TRACK REFURBISHMENT  
ESSEX HIGH SCHOOL  
TAPPAHANNOCK COUNTY, VIRGINIA  
APN 49566

ADDENDUM #1  
FEBRUARY 18, 2022

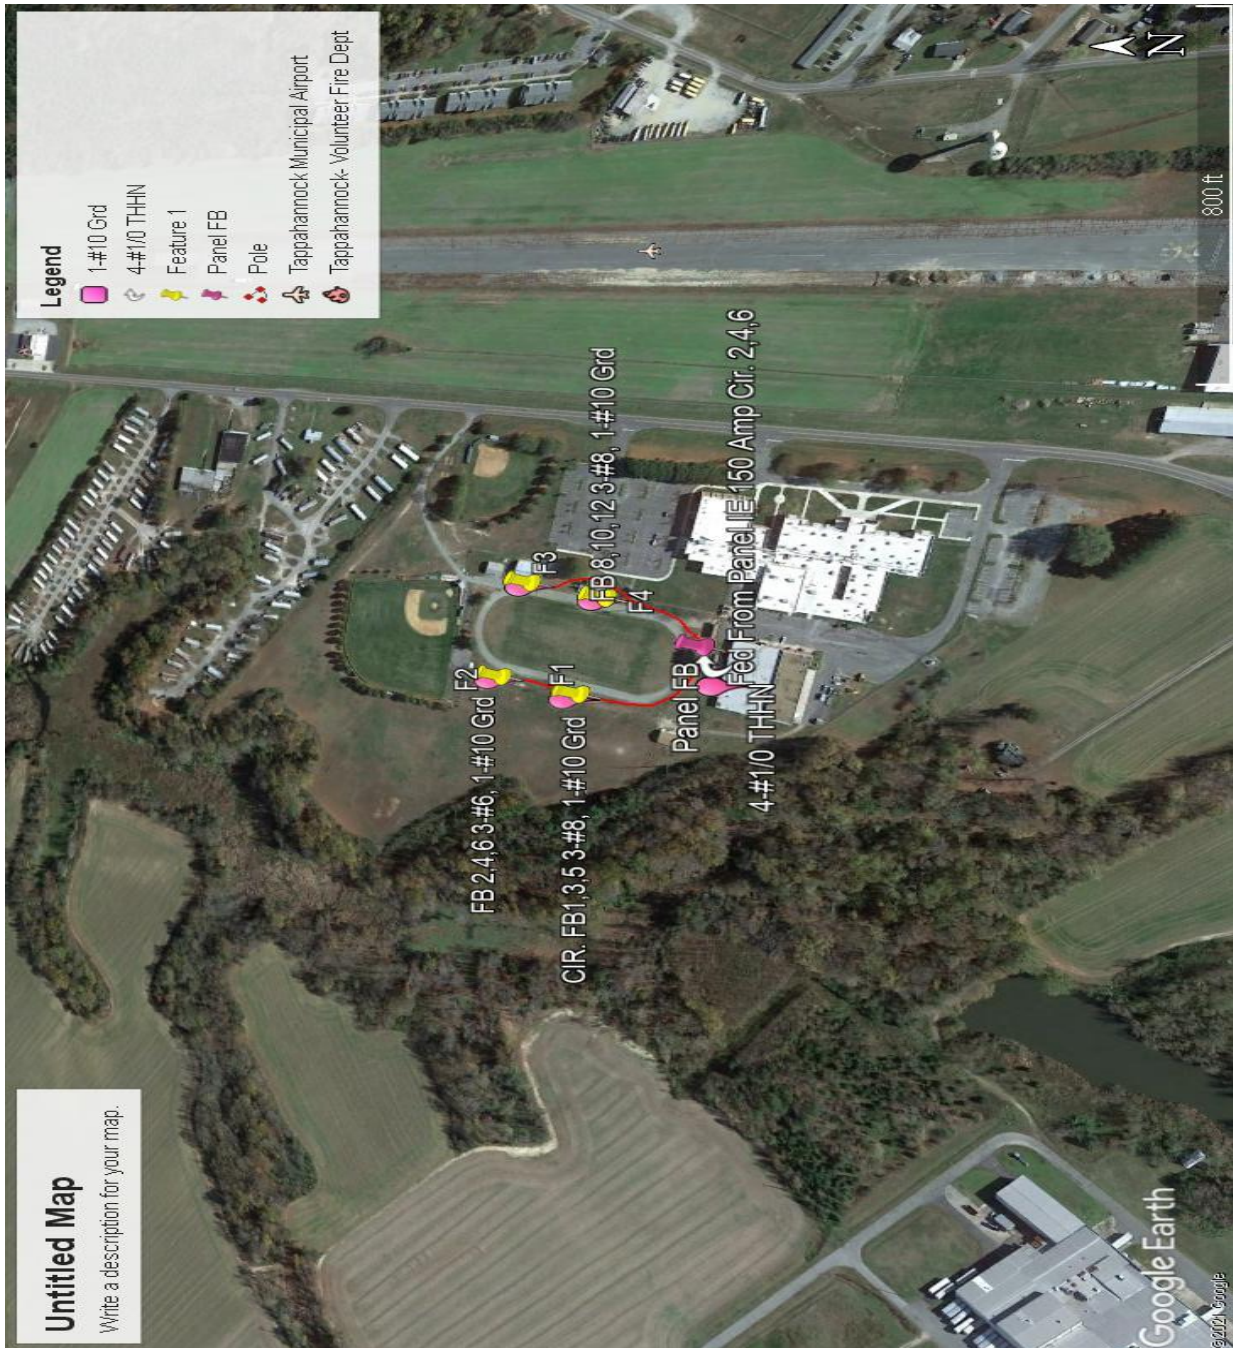
4. Attached is a wiring diagram for the Musco stadium lights that were installed a couple years ago. This information is being provided to help avoid damaging those lines during construction.

If the lighting is turned on it will be easier for any utility marking company to pick up the 60 hz. We also should have red marking tape in our ditches.
